# Access Compliance Report

## Public Rights-of-Way

### (Pedestrian Signals)

Intersection ID: N/A	Main Street:	Cross Street: N/A	Location: N/A
ADA ID: E0FA4C0B23C2	Signal Type: One Push Button-Non APS	Overall Compliance: No	Severity Score: BTN 1: N/A BTN 2: N/A No BTN: N/A
Codes/Mitigation Info/Possible Solution		Field Measurements/Component Compliance

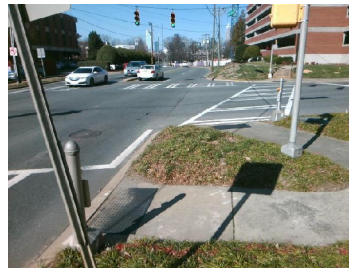
PROW/ADA: TMUTCD 4e.08, R404.2, R406.2

Possible Solutions: Replace Signal Push Button With APS Button on New Post. Remove & Relocate Sign.
